State of California
AIR RESOURCES BOARD

Final Statement of Reasons for Rulemaking, Including Summary of Comments and Agency Response

Public Hearing to Consider Proposed Amendments to the
Regulation on the Commercialization of Alternative Diesel
Fuels

Public Hearing Date: April 23, 2020
Agenda Item No.: 20-4-4

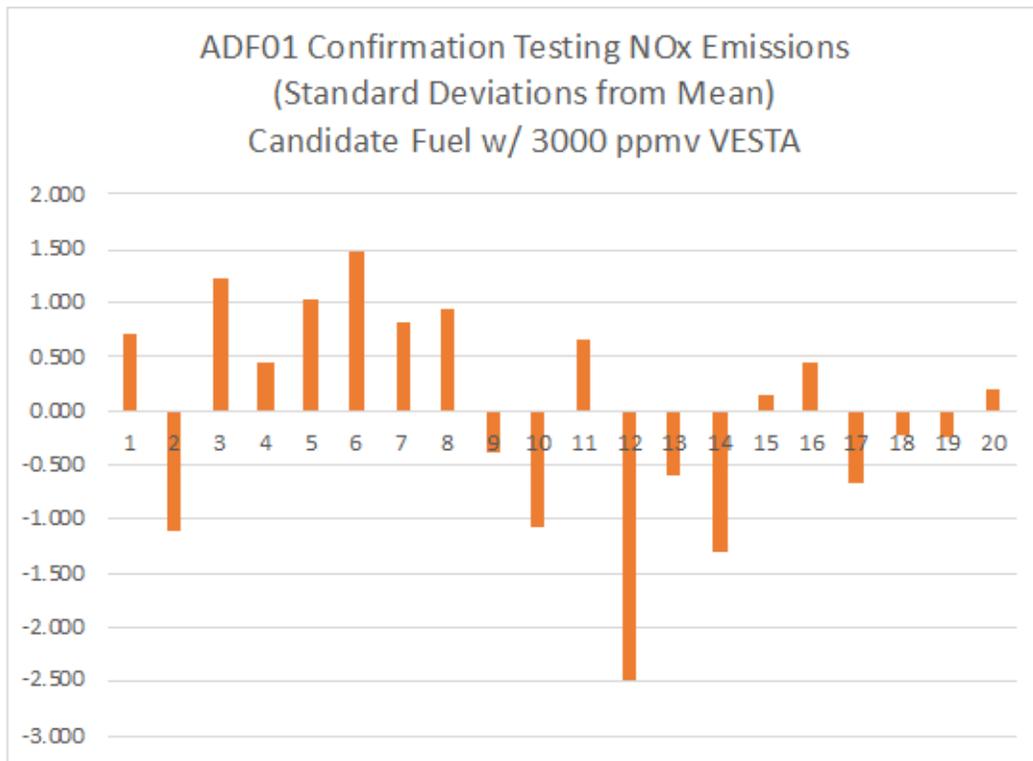
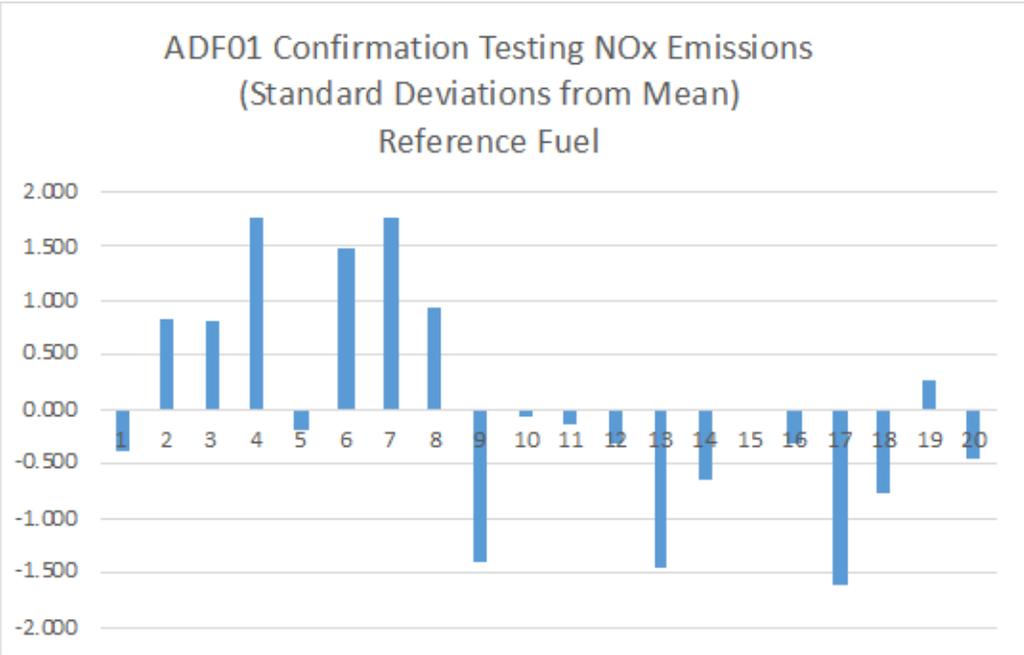
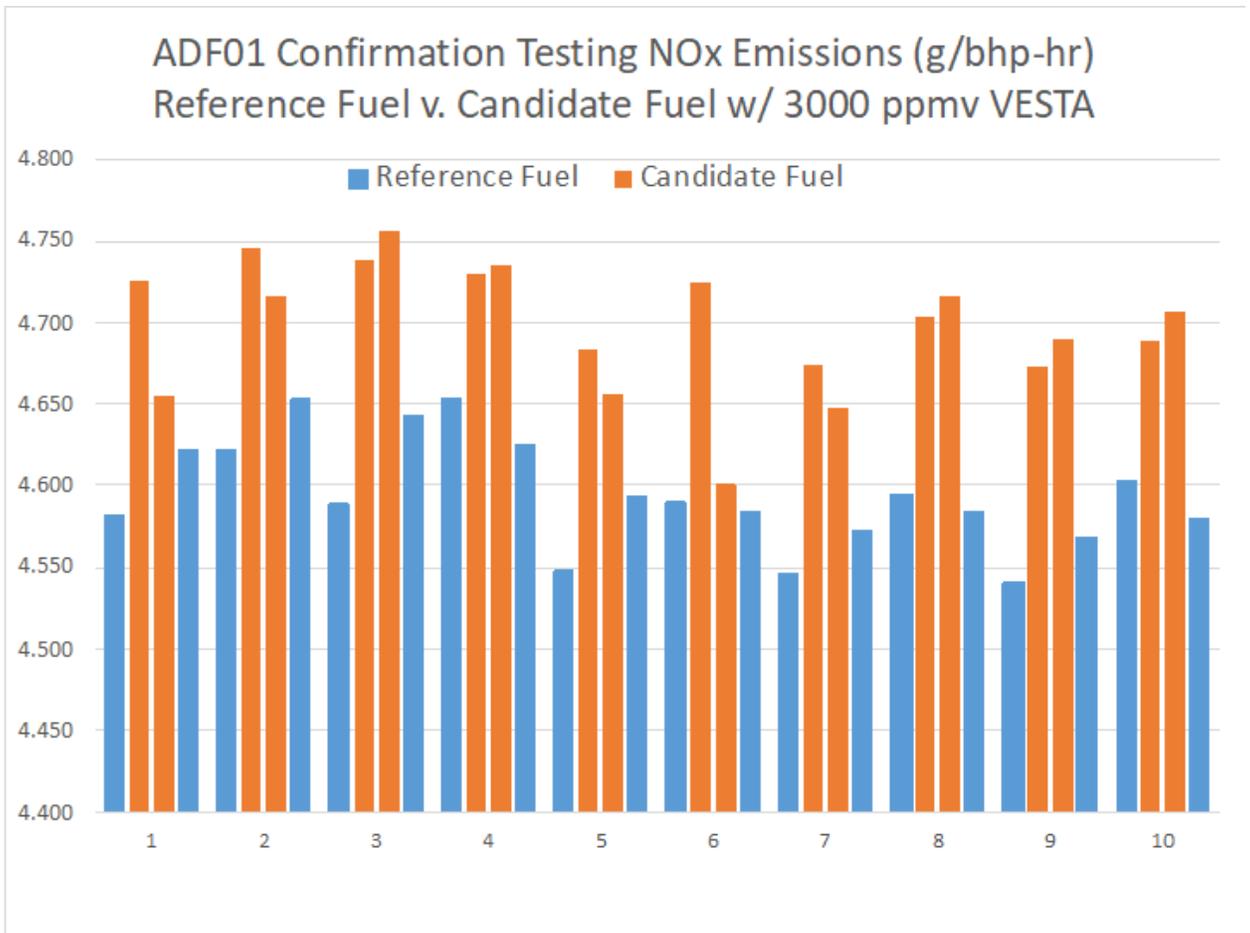
CARB staff also plotted ADF01 test data versus the number of standard deviations from the mean for the Candidate Fuel with 3000 ppmv VESTA and the Reference Fuel. As shown below, the greatest difference from the mean was about -2.5 standard deviations for one Candidate Fuel test. This contradicts the commenter’s concern of an “out of control” Candidate Fuel test of greater than +3 standard deviations high. So, the commenter’s concern that the Candidate Fuel emissions may be high is inaccurate. The summary chart below shows the absolute NOx emissions for the confirmatory testing of ADF01 for each of the tests performed on the Candidate Fuel and Reference Fuel. As shown, Candidate Fuel emissions were higher than Reference Fuel emissions for every back-to-back test pair in the test sequence.

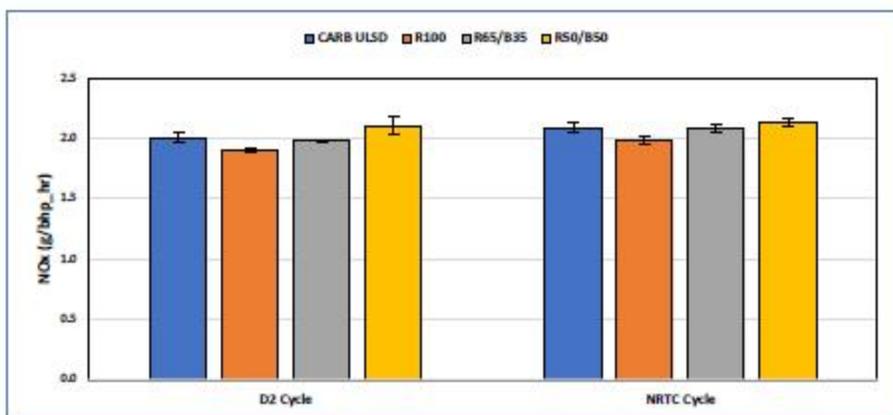
Earlier this year, CARB evaluated various renewable diesel and biodiesel blends as part of the LED program. The LED's test program legacy vehicle emissions results are provided on page 2. CARB's claim that "Staff's Supplemental Disclosure Discussion Analysis assumed a NOx decrease of 10 percent for R100", based on the staff report for the 2015 ADF regulation is now outdated based on the LED program's findings. CARB's 10% renewable diesel NOx reduction claim, based on the LED program emission data, is clearly inaccurate by a twofold factor. Based on the LED study's legacy vehicle emissions data, renewable diesel provides only a 5% NOx reduction versus a CARB ULSD. This finding alone significantly impacts CARB's past Environmental Analysis which will be addressed in a separate public comment. CARB has stated that B20 increases NOx 4%. Based on R100 reducing NOx by 5%, R55 is not capable of overcoming the 4% NOx increase from the addition of 20% biodiesel.

Questions: Did CARB consider the LED program's emissions data when drafting the proposed approval of R55? If not, why?
